Project	<b>IEEE 802.16 Broadband Wireless Access Working Group</b> < <a href="http://ieee802.org/16">http://ieee802.org/16</a> >	
Title	<b>A Key Management Method for the Multicast Service</b>	
Data Submitted	<b>2004-03-05</b>	
Source(s)	Seokheon Cho Ae Soon Park Chulsik Yoon SungCheol Chang Kyung Su Kim ETRI 161, Gajeong-dong, Yuseong-Gu, Daejeon, 305-350, Korea	Voice: +82-42-860-5524 Fax: +82-42-861-1966 <a href="mailto:chosh@etri.re.kr">chosh@etri.re.kr</a> <a href="mailto:aspark@etri.re.kr">aspark@etri.re.kr</a>
Re:	This is a response to a Ballot #14 Announcement IEEE 802.16-04/06 on IEEE P802.16e-D1.	
Abstract	The document contains suggestions on the changes in IEEE P802.16e-D1 that would support to negotiate authorization policy between the existing device authentication and the user authentication.	
Purpose	The document is submitted for review by 802.16 Working Group members	
Notice	This document has been prepared to assist IEEE 802.16. It is offered as a basis for discussion and is not binding on the contributing individual(s) or organization(s). The material in this document is subject to change in form and content after further study. The contributor(s) reserve(s) the rig

**Figure 127 - TEK state machine flow diagram**

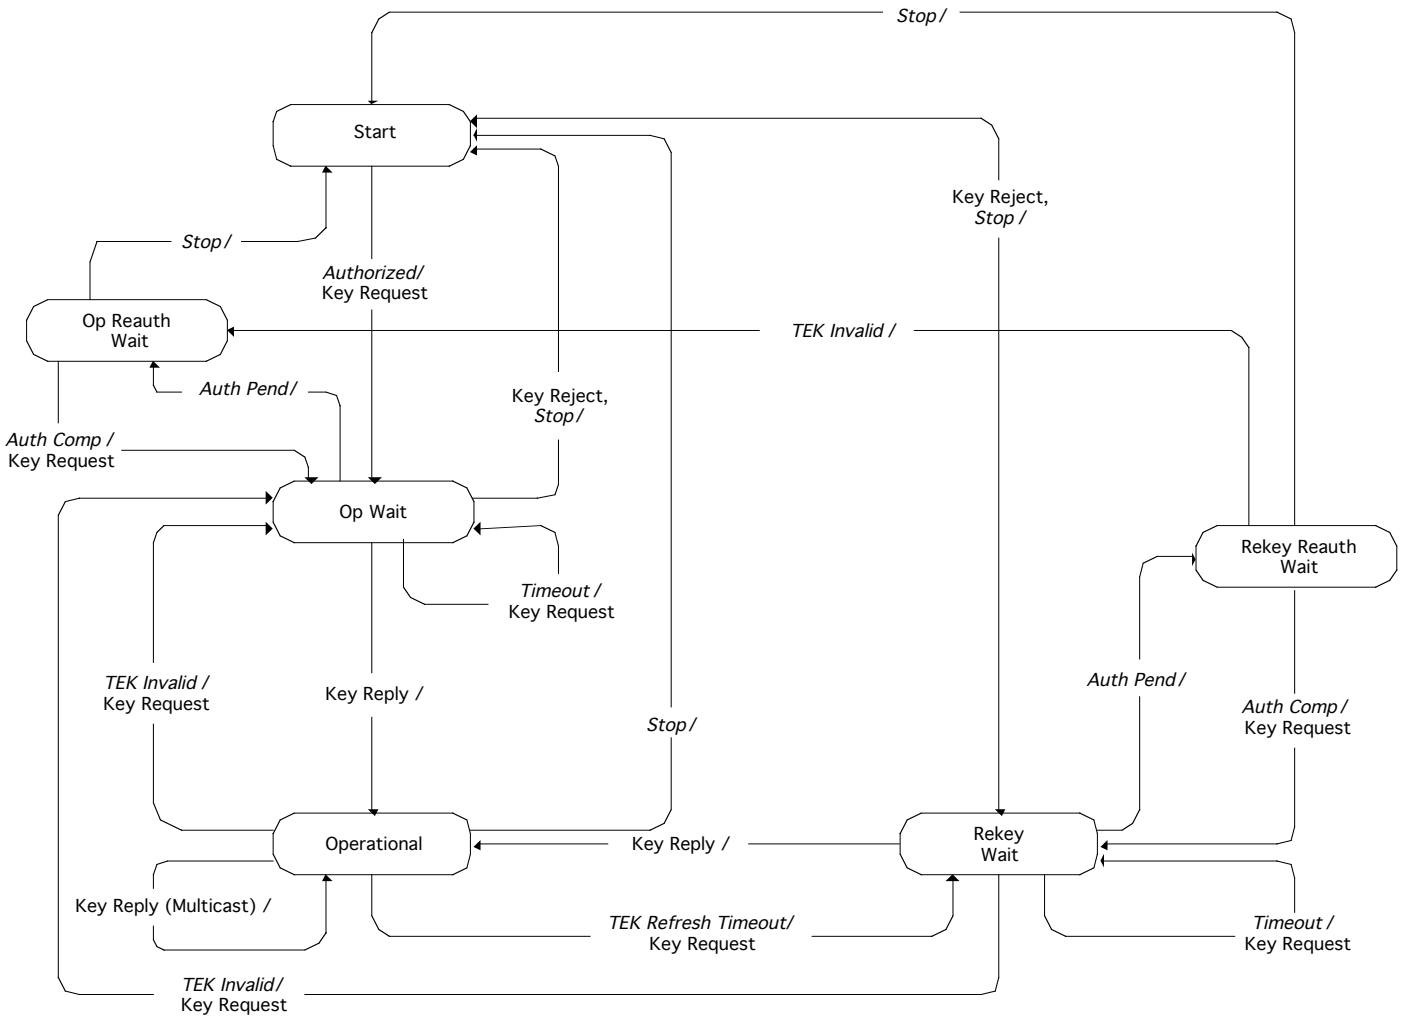
*[Change the Figure 127]*

NOTE: The state, Operational (D), can be transitioned to the “Operational” state by receiving the Key Reply message for the multicast transport service such as “8-D”.

8-D Operational (Key Reply: Multicast) → Operational

- process contents of Key Reply message and incorporate new keying material into key database
- set the TEK refresh timer to go off “TEK Grace Time” seconds prior to the key’s scheduled expiration
